Construction Division
Additions & Alteration Charges Approval Form

GULMOHAR RESIDENCY

Details of Additions & Alterations

Flat No	306	Block no.	'H'
Flat Area	1360 sft	Type	Deluxe / Luxury
Buyer Name	Mr. Chandrabha <i>Choudary</i>		
Phone No.		Email

Changes in kitchen platform: (mark on plan)

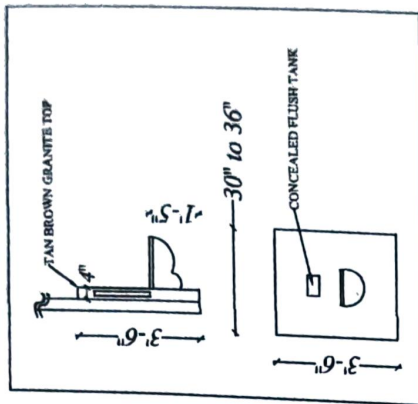
→ shown in plan -

- 1) Kitchen Platform dismantling only. cc Platform. not laid down. Extra charges = for breaking Platform beam by customer
